- 1) Addendum Number Four (4) Acknowledgement Form
- 2) '025 UNIT PRICING FORM', dated June 10, 2016, Addendum No. 4
- 3) '025 UNIT PRICING FORM' (Electronic Spreadsheet), dated June 10, 2016, Addendum No. 4
- 4) '060 Supplemental Conditions', dated June 10, 2016, Addendum No. 4
- 5) Revised Plan Sheet drawings (10 sheets)
- 6) Image Depicting Available Equipment Storage Area,

06/13/2016

PROJECT NAME: Runway 12R - 30L Electrical Improvements and Terminal Area Taxiway Improvements (Package 4)

PROJECT NO. 33-00178 & 33-00193 (AIP NO 3-48-0192-XX-2015)

**OVERALL PHASING
PLAN**

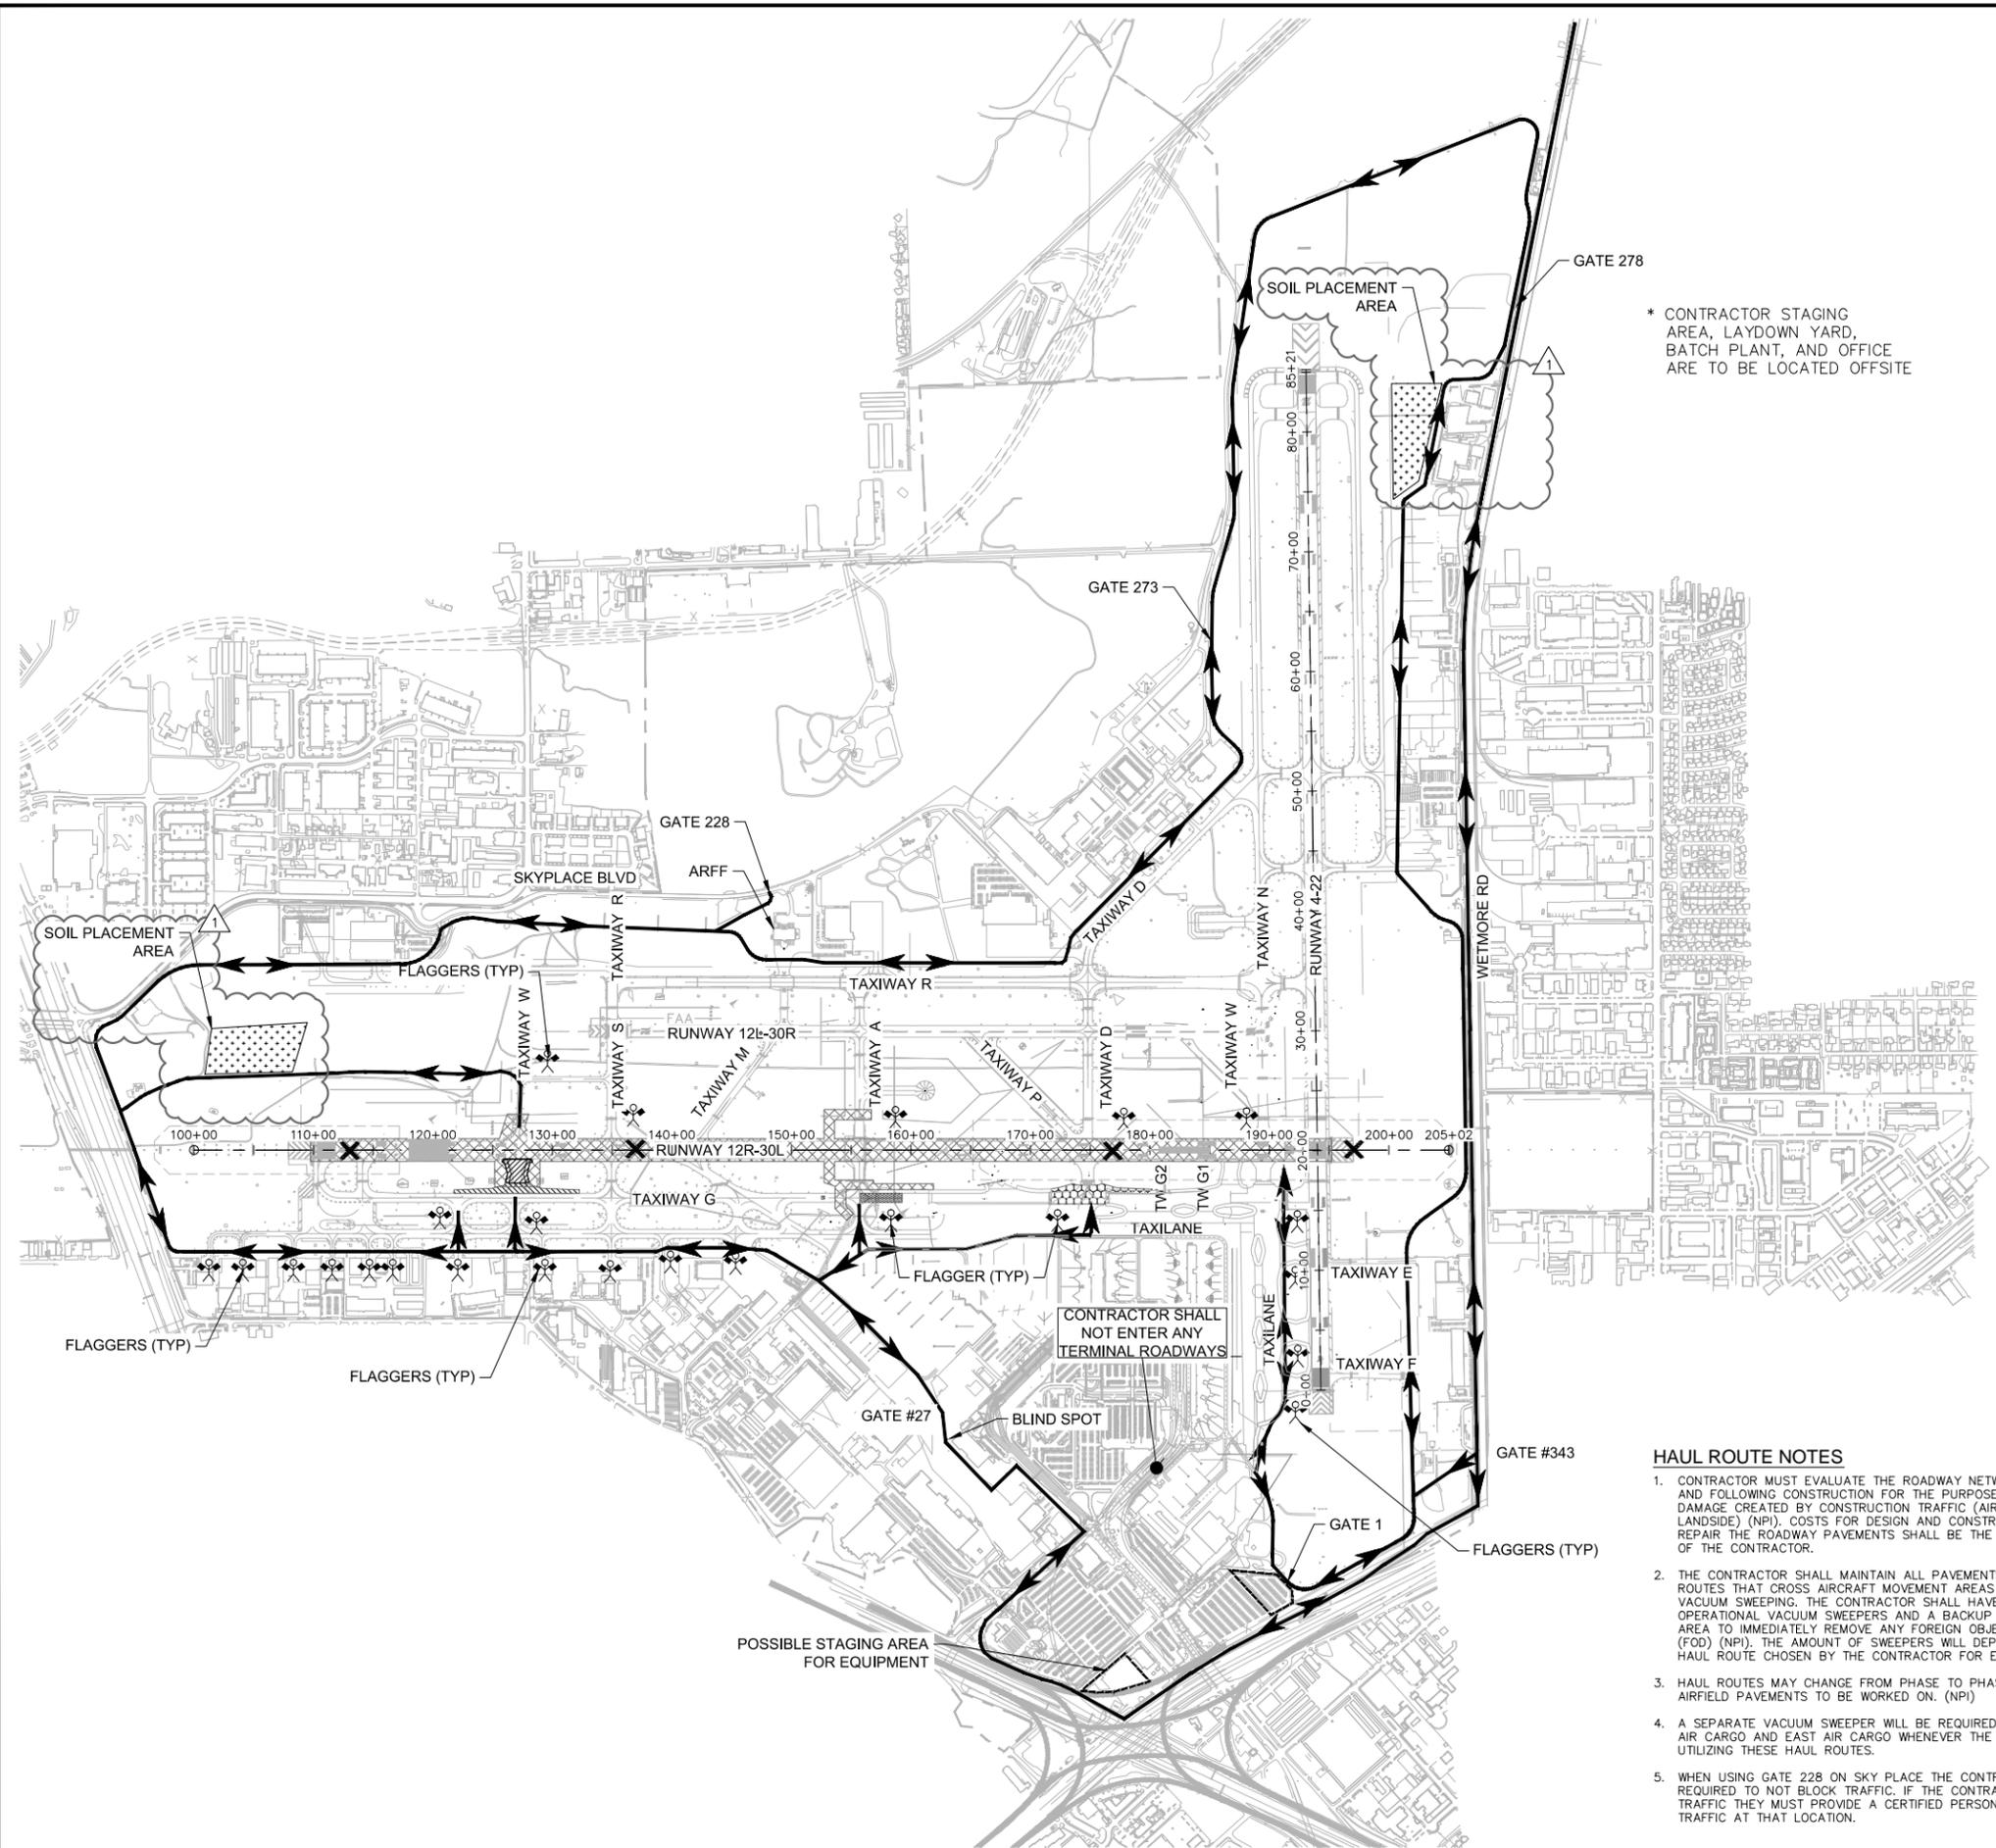
AMMA
A Modifications have been made to section "060 Supplemental Conditions" and three plans sheets as distributed in this Addendum.

A No – Alternate 2 must be completed separate. Modifications were made and distributed in this Addendum.

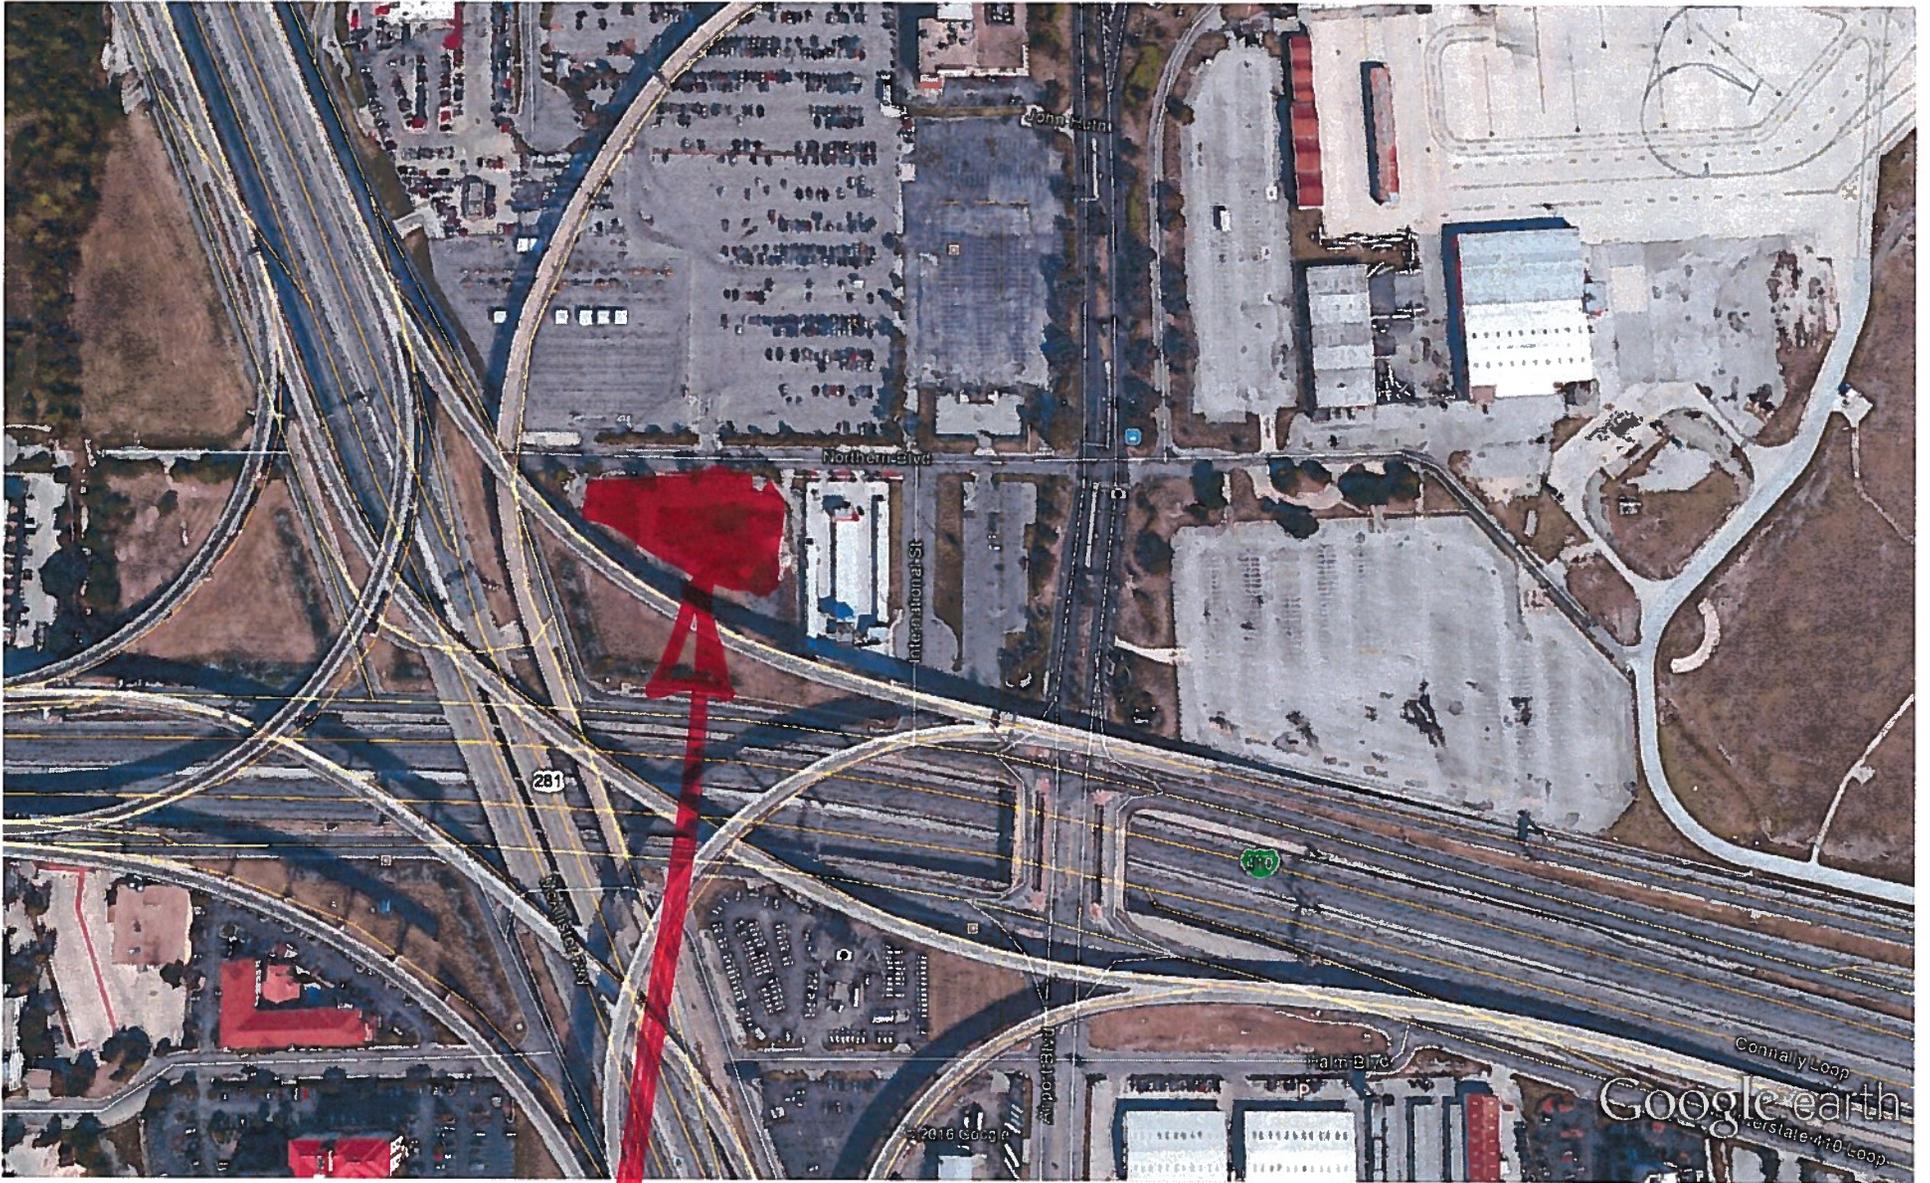
A I have attached a drawing that depicts one of these areas that is still available for storage of equipment etc. However, it is not large enough for a full staging area. In addition, if this area is used, the contractor has to perform test on the soil based on the Aviation Soil Management Plan to establish the baseline for the site before the site is used. It is the Contractors responsibility at the end of the project, to return the site back to the original condition.
